The Commission has issued the enclosed Amendment Nos. 40 and 63 to Facility Operating Licenses Nos. DPR-71 and DPR-62 for the Brunswick Steam Electric Plant, Units 1 and 2. The amendments consist of changes to the Technical Specifications in response to your submittal of May 13, 1981.

These amendments change the Technical Specifications to delete Sample Station No. 36 from the Radiological Environmental Monitoring Program. We have made some clerical changes to your proposed Technical Specification revisions. These changes have been discussed with and agreed to by members of your staff.

BRUNSWICK STEAM ELECTRIC PLANT, UNIT NO. 1

SAFETY EVALUATION BY THE OFFICE OF NUCLEAR REACTOR REGULATION
SUPPORTING AMENDMENT NO. 40 TO FACILITY LICENSE NO. DPR-71 AND
AMENDMENT NO. 63 TO FACILITY LICENSE NO. DPR-62
CAROLINA POWER & LIGHT COMPANY
BRUNSWICK STEAM ELECTRIC PLANT, UNIT NOS. 1 AND 2
DOCKET NOS. 50-325 AND 50-324

FIGURE NO. 4.2-1b

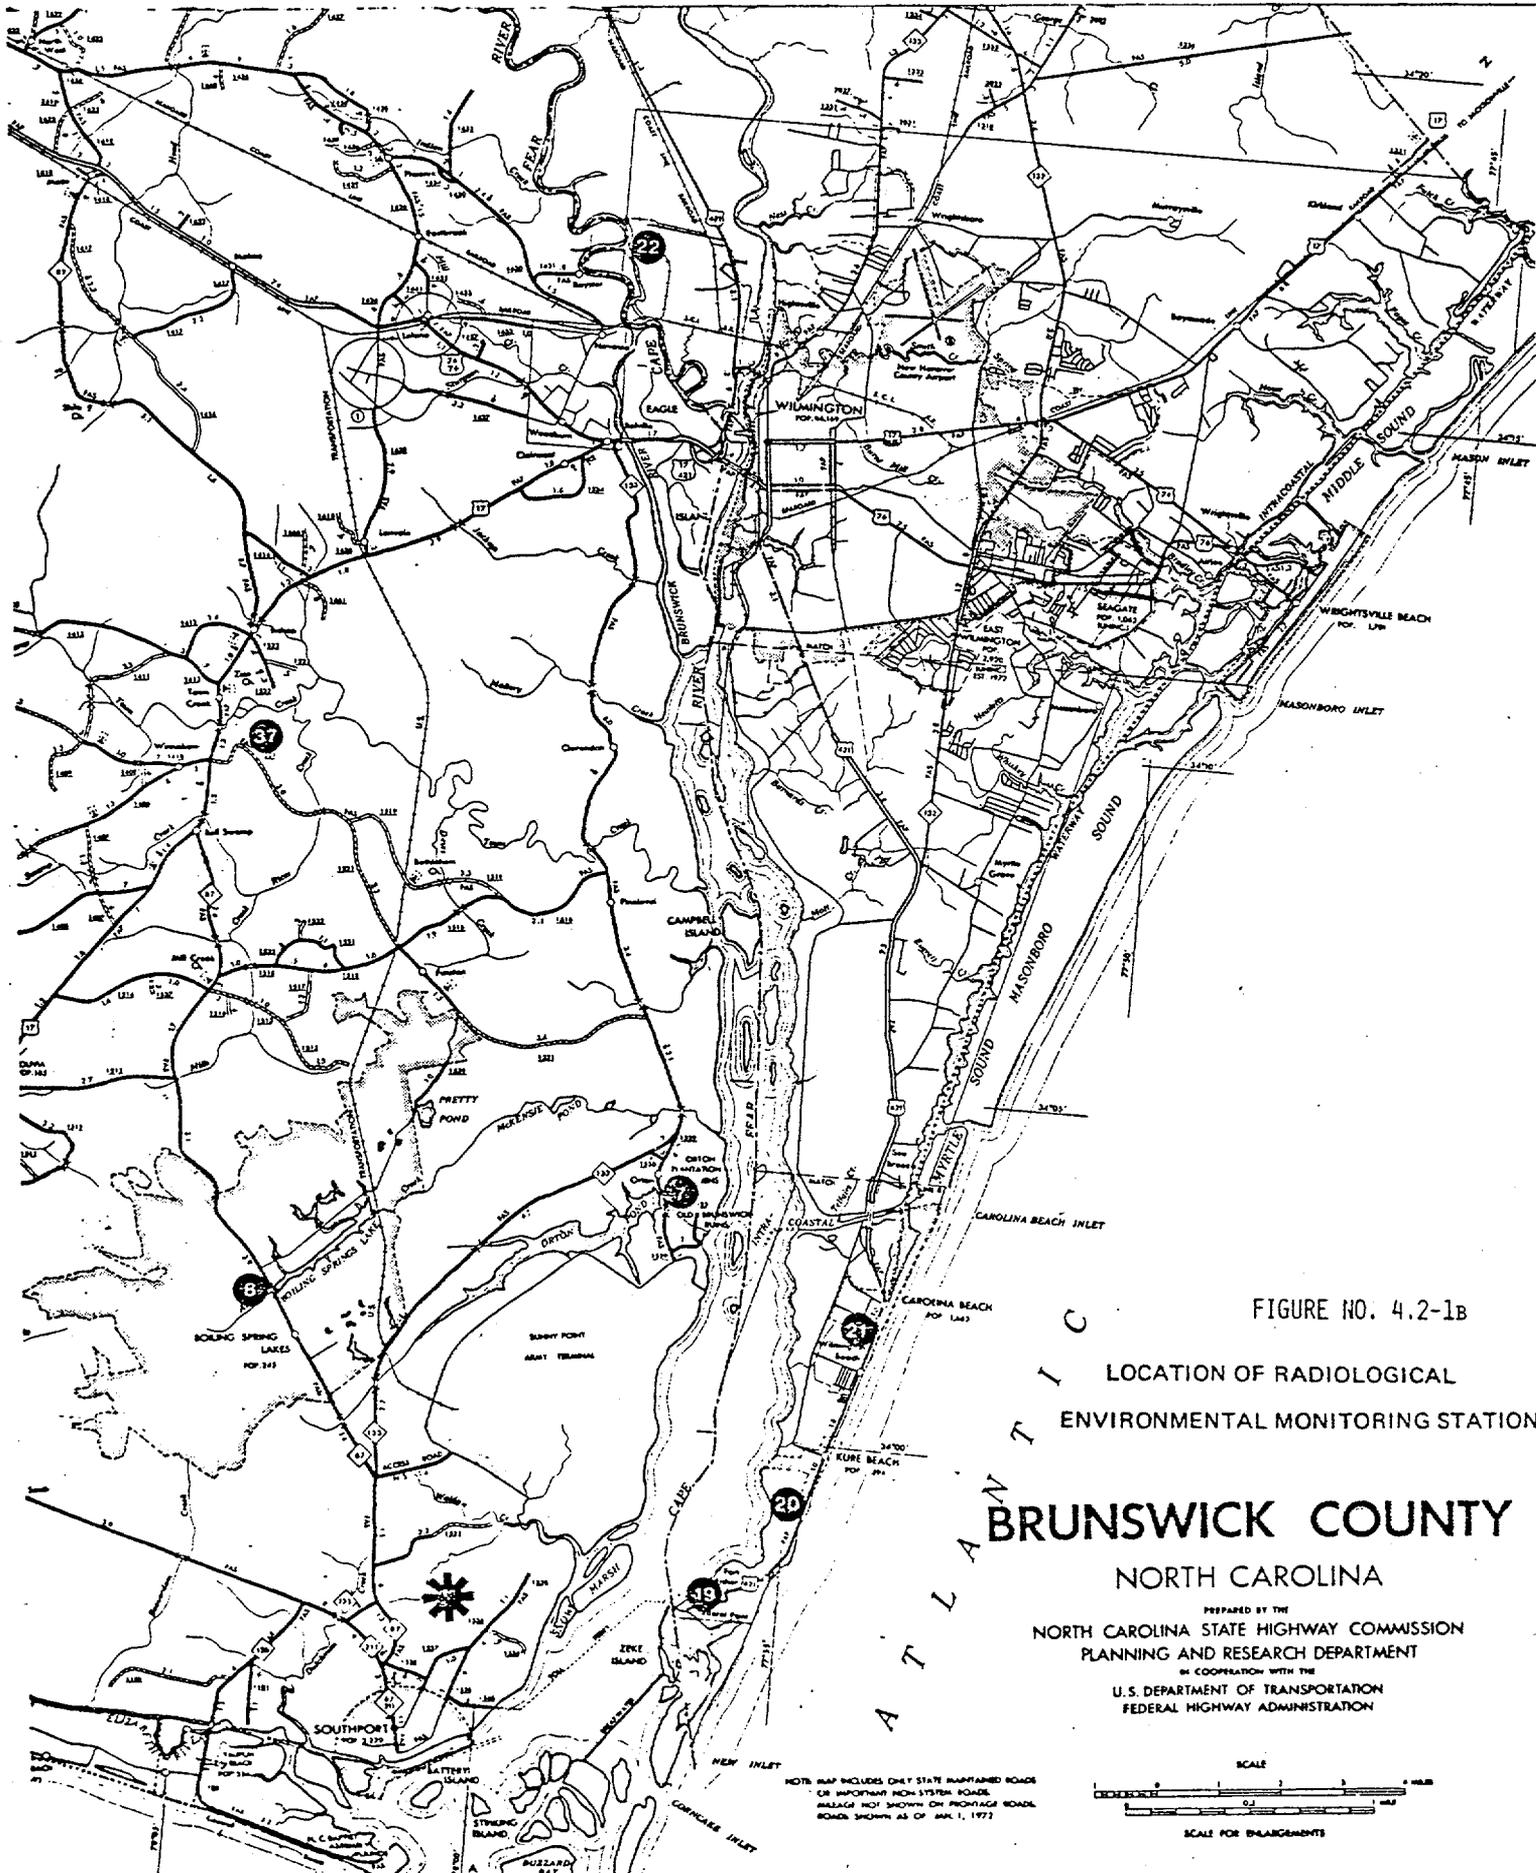
The amendments revise the Technical Specifications to delete one sample station from the Radiological Environmental Monitoring Program.
